STATE BANK
Interior Alterations
Napoleon, Ohio

C5-5034

ADDENDUM 2

ITEM NO. 2: Sheet A-101 – Door Schedule

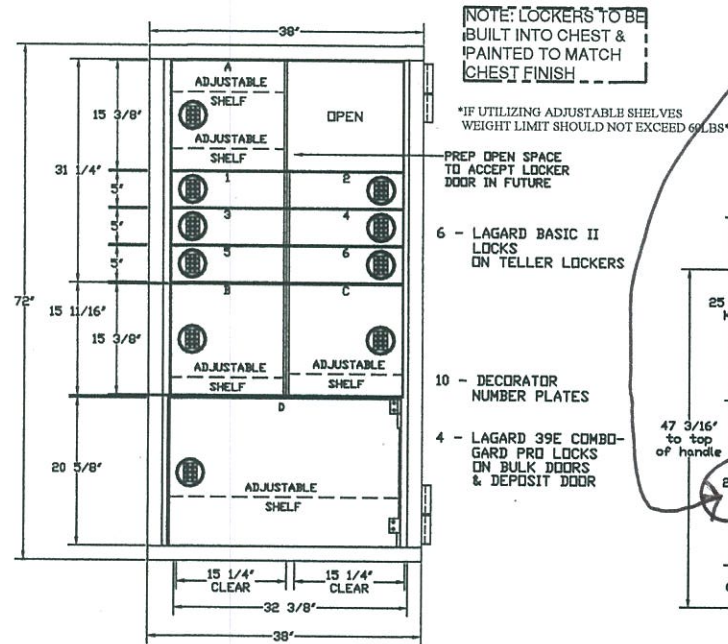
Delete Hdw. Set column.
